# HydroQuest

Comments by Paul A. Rubin

July 20, 2016

F-2016-0092 - Consistency Determination for the Mamaroneck and Sheldrake Rivers Flood Risk Management Project, Village of Mamaroneck, New York

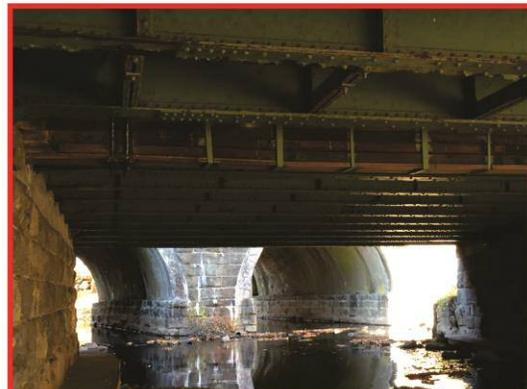
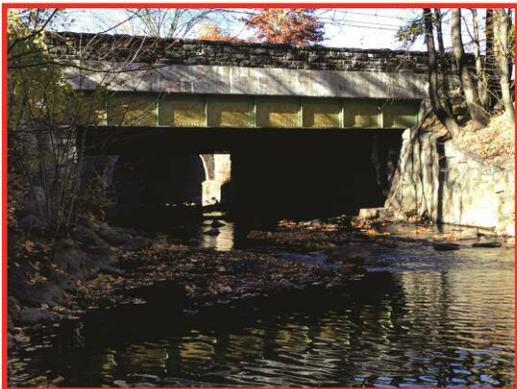
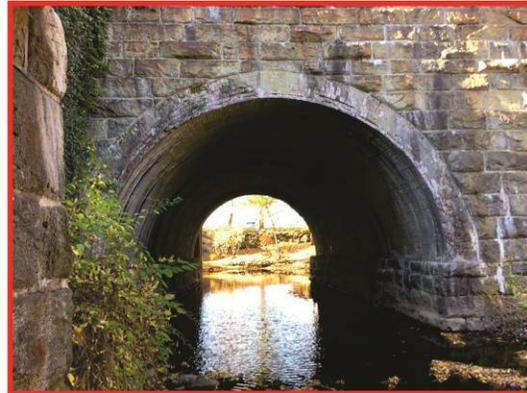
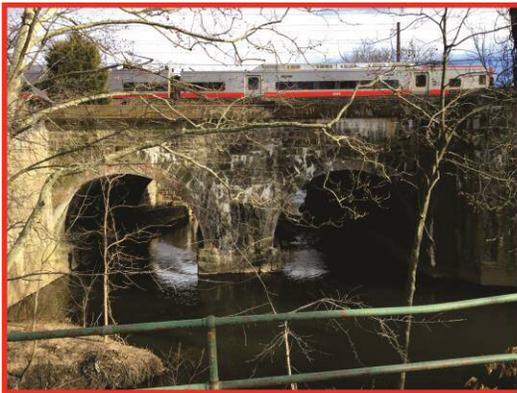
Planned channel modification along the Sheldrake and Mamaroneck rivers involves lengthy trapezoidal cuts. As stated in the June 6, 2016 report: “*Trapezoidal channel improvements will consist of a natural bed channel with **grassy side slopes** of one vertical on two and a half horizontal (1:2.5). Concrete retaining walls will be used where space is limited. Removal and replacement of existing retaining walls and utilities will be necessary **along the length of the channel**. Several small bridges will be removed and one bridge will be replaced.*” (emphasis added) While these grassy sloped cuts would allow river access, and are an improvement from old school solid cement channel walls depicted below in a Juneau, Alaska photograph, they are not supportive of healthy river environments.

# Flood Plain and Wetland Boundaries with Tunnel Options

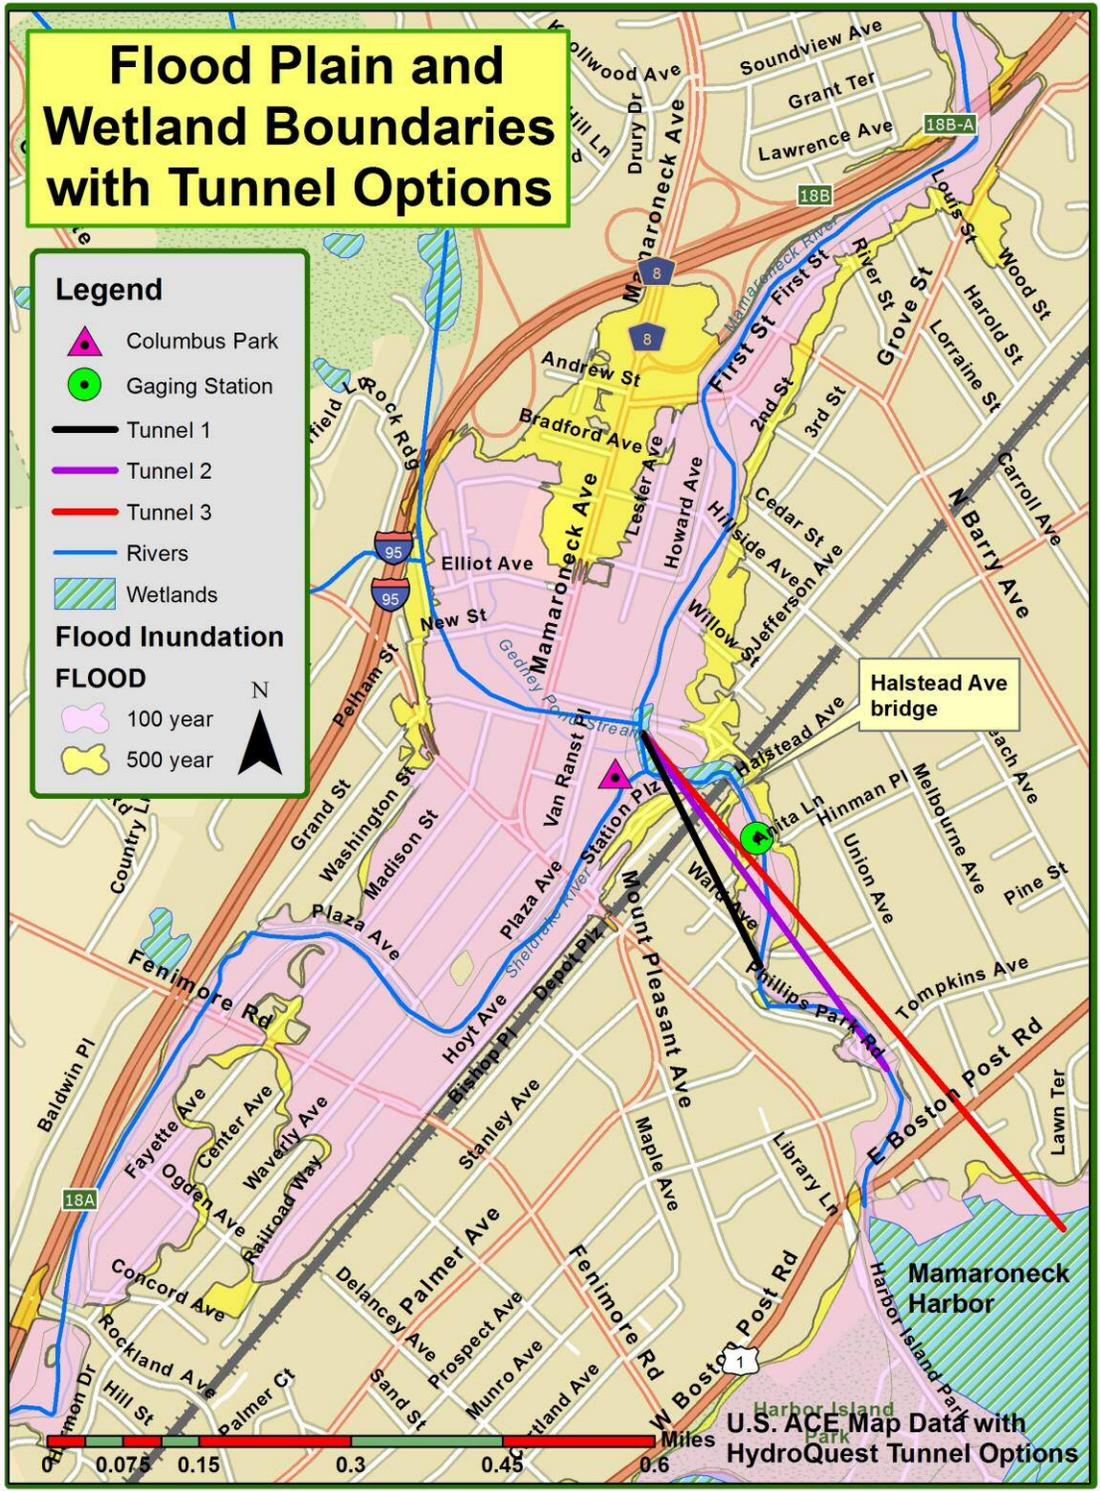
Tunnel construction initiated at junction of the Mamaroneck River and the Jefferson Street parking lot could be designed without any unnatural alteration of either Sheldrake or Mamaroneck rivers (e.g., channel dredging, channel and/or bank armoring, channel widening, upriver channel modification). The Jefferson Street parking lot location is ideally suited because a tunnel constructed there could effectively conduct much of the Mamaroneck River discharge away from Columbus Park prior to its confluence with Sheldrake River. Thus, river floodwater volume reduction incident to the Halstead Avenue Bridge would be greatly reduced by effectively splitting much of the current floodwater flow between the Railroad bridge cement shoot and a tunnel. This would result in reduced in and out-of-channel floodwater inundation upriver of Columbus Park and, therefore, reduced or no upriver overbank floodwater inundation.

For this splitting of river discharge to function well (i.e., water volume reduction), a carefully engineered tunnel inlet control structure is required. This structure would be constructed directly along the east bank of the Mamaroneck River at a predetermined river stage elevation. For example, the elevation selected might be one foot above a river base flow elevation. A concrete control structure mimicking that constructed at the outlet of the Shandaken Tunnel on the Esopus Creek in the Catskill Mountains (USGS 01362230 Diversion from Schoharie Reservoir). There, a 40 foot wide control structure maintains a desired outflow elevation and is designed to funnel water flow toward its center via a slightly down curving arcuate shape. If constructed, when the Mamaroneck River reaches the predetermined elevation, river discharge would be shunted into the tunnel. Project design should include construction of a few in-channel rock weirs or vanes designed to help direct river water into the tunnel and reduce erosion. The Shandaken Tunnel concrete control structure is depicted below:
